# SITE TECHNICAL BULLETIN

**NUMBER:** STB-RIT-003

**SYSTEM/TYPE:** EnRoute Radar Intelligent Tool (ERIT)

**SUBJECT:** ERIT System Rack / Interface Cable Engineering Change Order

TITLE: ERJT SYSTEM CABLE ASSEMBLY DWG NO: 8014.2-L REV **A** TO **B**

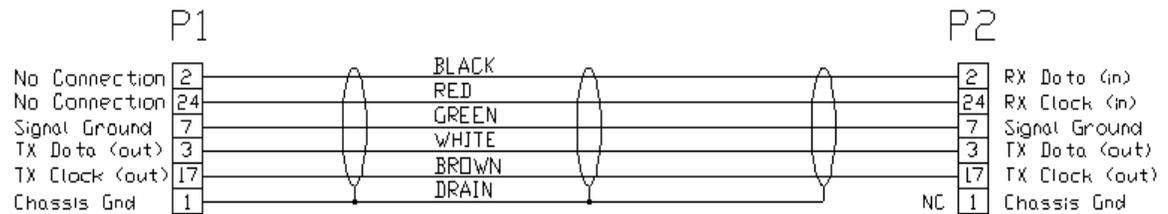
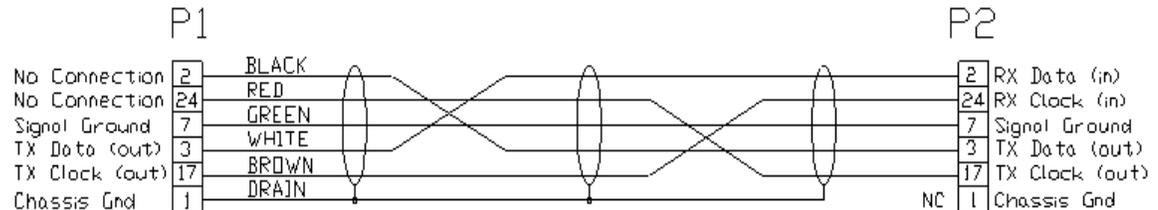
REASON The 'Rev A' ERIT cables which were shipped to the field were pinned incorrectly. This is because the cables are standard RS232 pinout. An RS232 cable normally connects a DCE (Data Communications Equip) to DTE (Data Terminal Equipment). However, both the modem splitters and the RDI system emulate a DCE (Data Communications Equipment). That is, they both transmit data on pin 3 and they both transmit clock on pin 17. Also, they both receive data on pin 2 and they both receive clock on pin 24. Therefore, one end of the cable will have to be repinned. Pins 2 and 3 will have to be swapped and pins 17 and 24 will have to be swapped.

On drawing 8014.2-L REV A at coordinates A4 thru A8, change

SHEET 3 OF 3

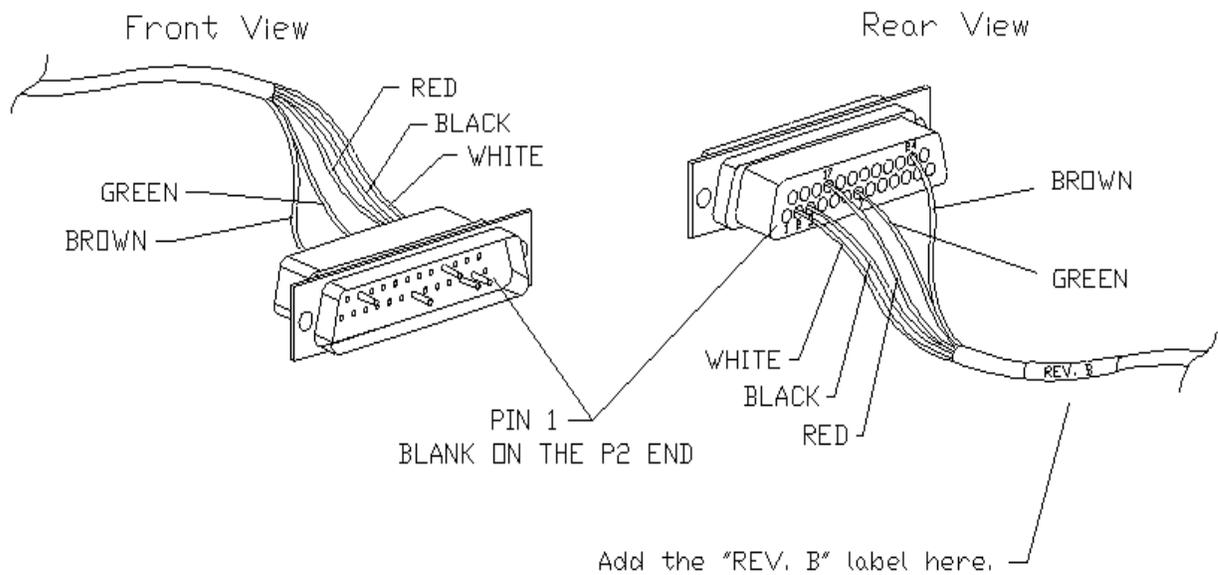
- 5) Remove pin 3 (the white wire) in a similar manner (as in steps 3 @ 4).
- 6) Swap pins 2 and 3 and reinsert the pins back into the connector housing such that the white wire is now connected to pin 2 and the black to pin 3. Make sure the pins snap back into place in the connector housing. Reference the drawings on sheet 3.

- 10) Prior to reinstalling the backshell, recheck the wiring to make sure it is right. The white wire should be going to pin 2, the black to pin 3, the red to pin 17, and the brown to pin 24. Green, unchanged, is still pin 7. Reference the drawings on sheet 3.

## **ERIT System Cable Assembly**

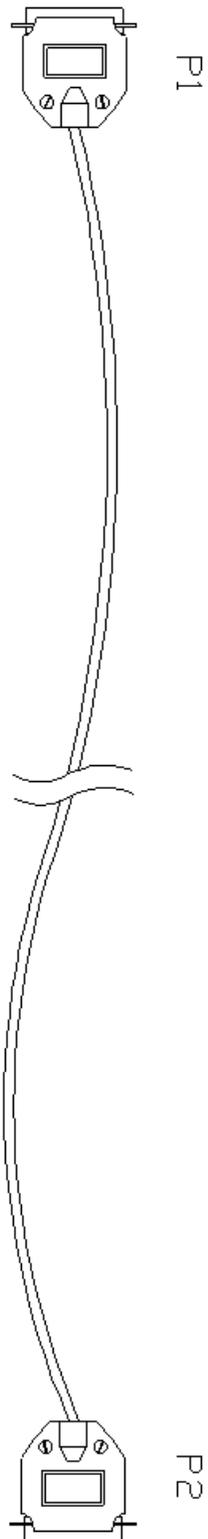
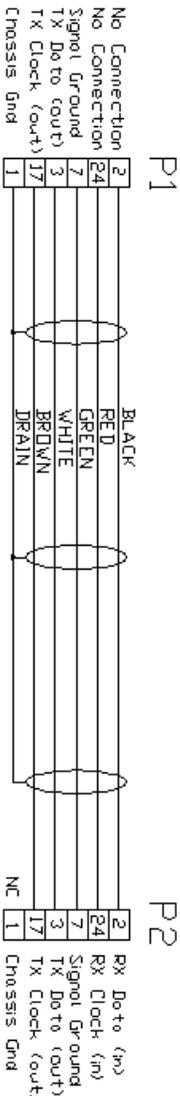
**7. RECOMMENDED SOLUTION.** Follow the directions provided in Attachment 1 and depicted in Attachments 2 and 3. Attachment 4 provides guidance for using the velcro, cable ties, and wire tie mounts.

## **ERIT System Cable Assembly (After ECO Implementation)**

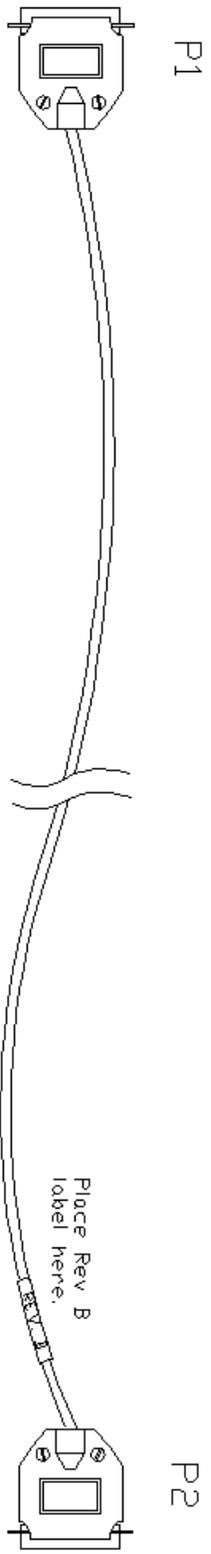
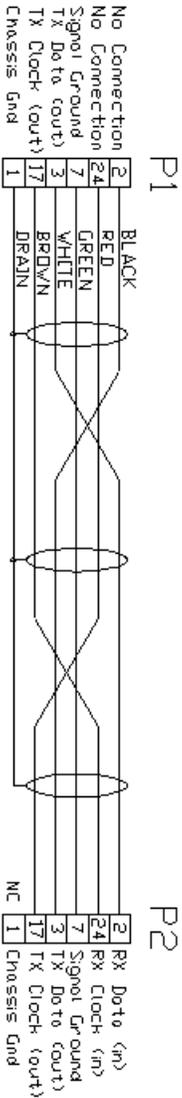
Note: For cable lengths exceeding 100 ft., use low cap cable (<15 pf/ft).

Twist Pair RX Data with TX Data  
Twist Pair RX Clock with TX Clock.  
Signal Gnd stands alone (not twisted).

## **ERIT Recorder**

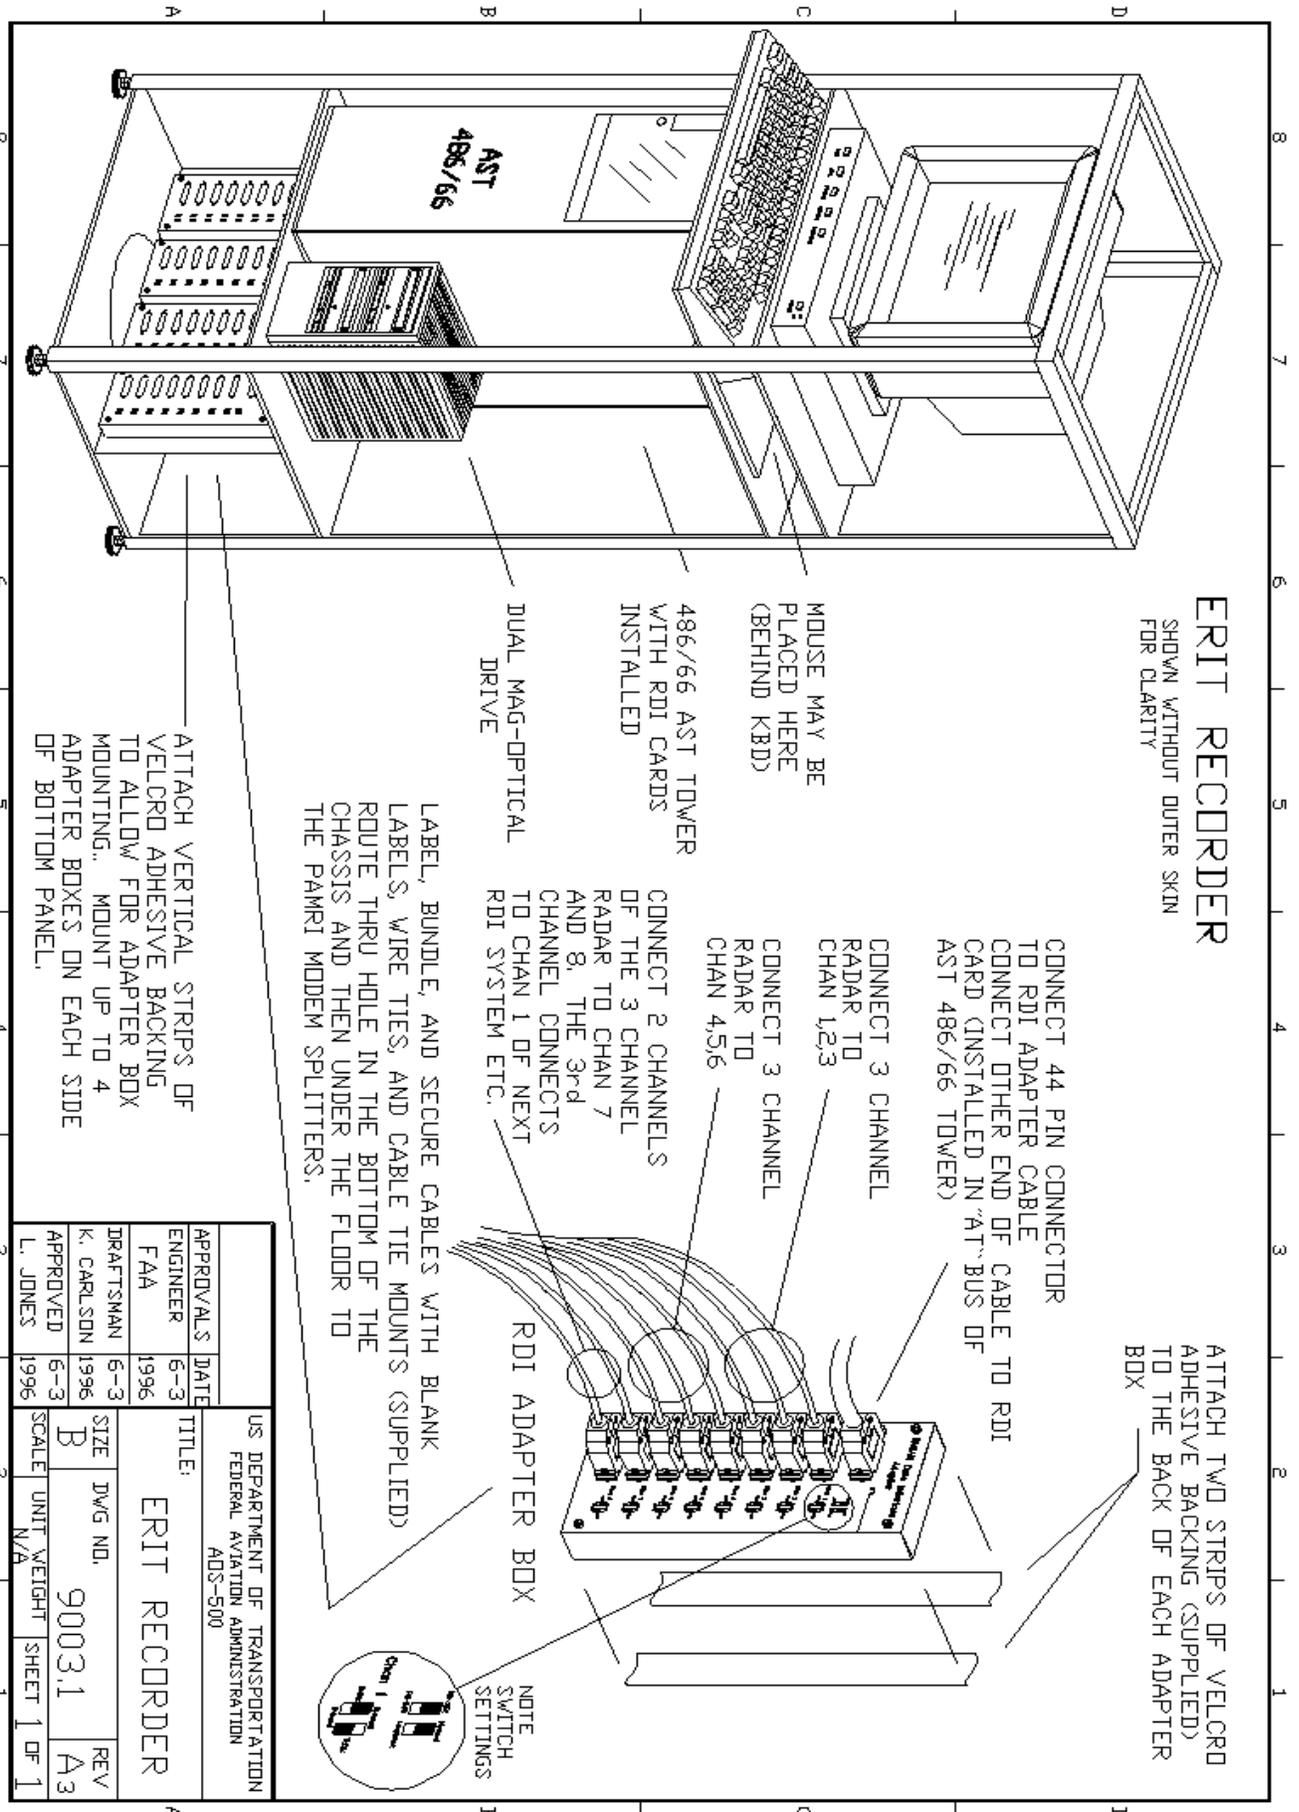
In order to neatly install the cables and dress them, a number of blank cable labels, cable ties, wire tie mounts, and 3M Velcro hook/loop strips are provided in Attachment 6. Attachment 4, drawing 9003.1 Rev. A3, ERIT Recorder provides guidance on the use of these items.

LABEL, BUNDLE, AND SECURE CABLES WITH BLANK LABELS, WIRE TIES, AND CABLE TIE MOUNTS (SUPPLIED) ROUTE THRU HOLE IN THE BOTTOM OF THE CHASSIS AND THEN UNDER THE FLOOR TO THE PAMRI MODEM SPLITTERS.
